Central Zoo Authority

F. No. 19-58/93-CZA(190)(Vol. III)(M)/1780

Sub:- Designs for the construction of Leopard and Bear enclosure at Manipur Zoological Garden, Imphal and Master (layout) Plan of the Zoo.

The designs for the construction of Leopard and Bear enclosure at Manipur Zoological Garden, Imphal and Master (layout) Plan of the Zoo were placed before the Expert Group of Zoo Designing Meeting held on 20th September 2012. The members scrutinized the designs and Master (layout) Plan and following observations were made:-

PLAN Scale 1:100

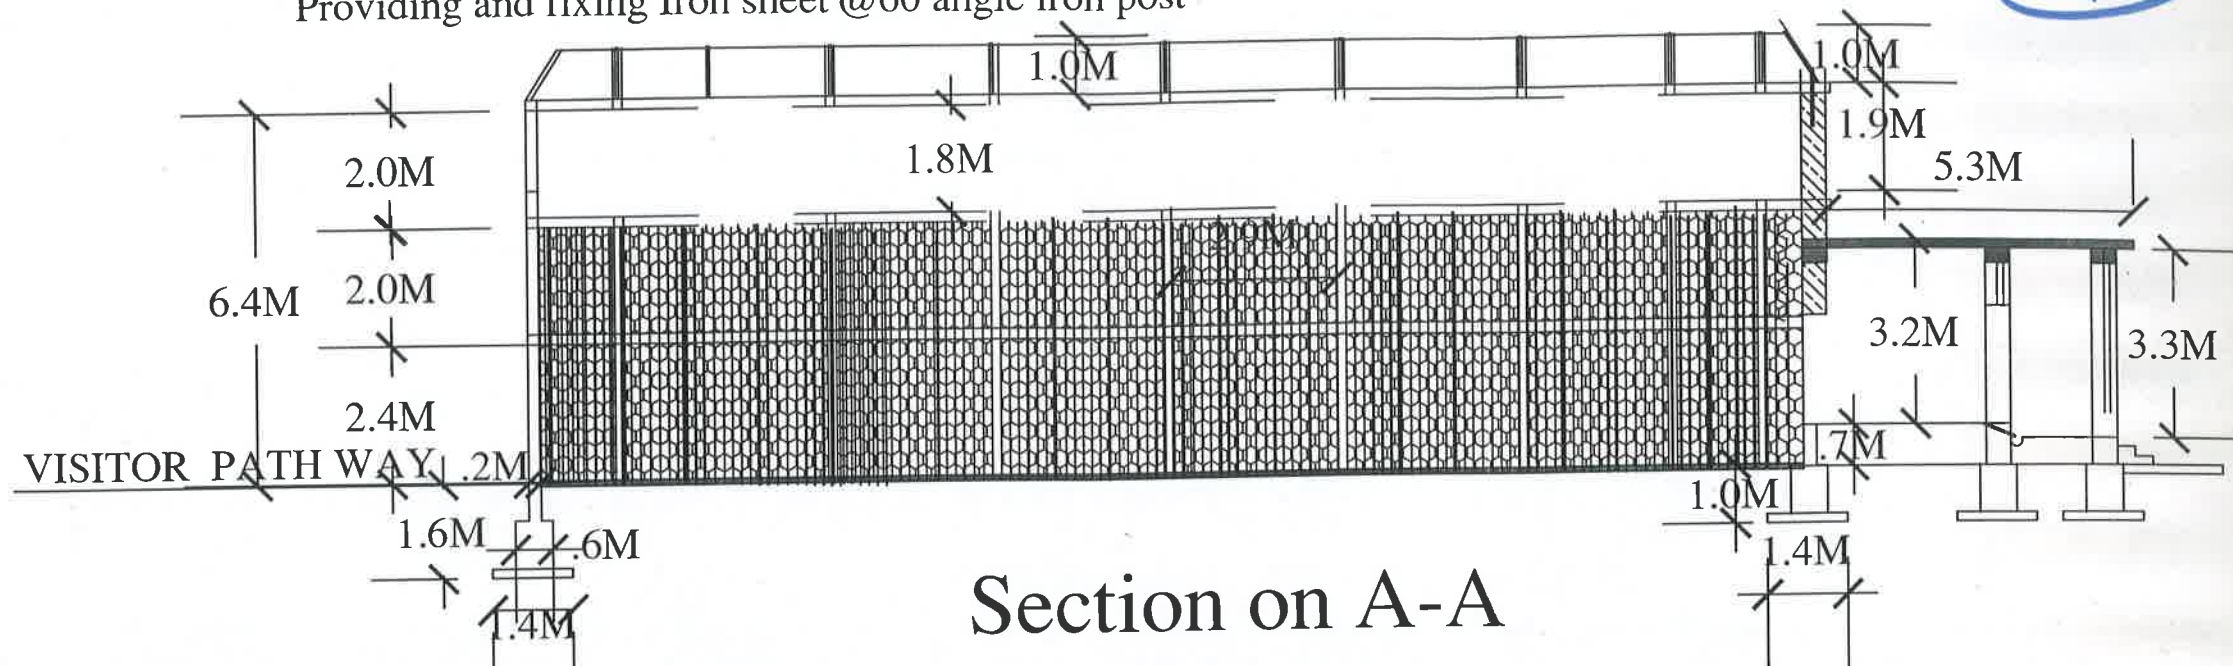
- (a) There should be four feeding and retiring cells.
- (b) The size of the kraal should be of 10meterx5.5 meter.
- (c) The viewer side should only have moat as prescribed by the Central Zoo Authority rest of the area should have a naturalistic wall of 3 meter high instead of chain-link fence.
- (d) The wall should be screened with small shrubs and climbers.

Section on A-A

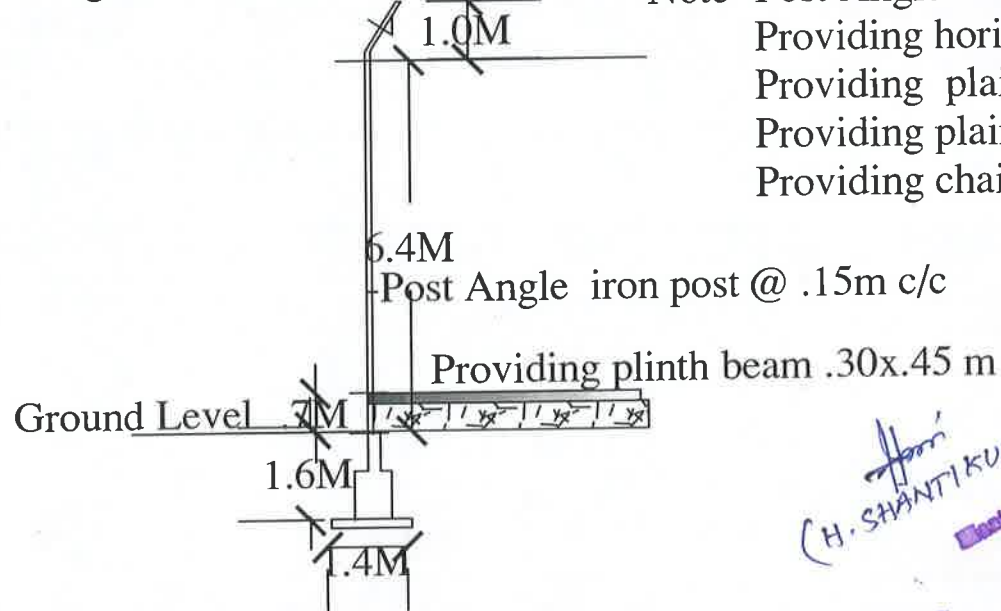
- There should be four feeding and retiring cells.
- The kraal should be shifted away from the visitor's area.
- The total height of the vertical fence should be kept 5 mt. and overhang should be at 60 degree angle of 1.5 meter wide.
- The overhang should use the MS sheet only instead of chain-link fence.
- No iron plate should be used on vertical fence.
- The chain-link fence should be fixed on the inner side of the fence.
- The chain-link fence should be of 5cm x 5cm x 10 gauge.
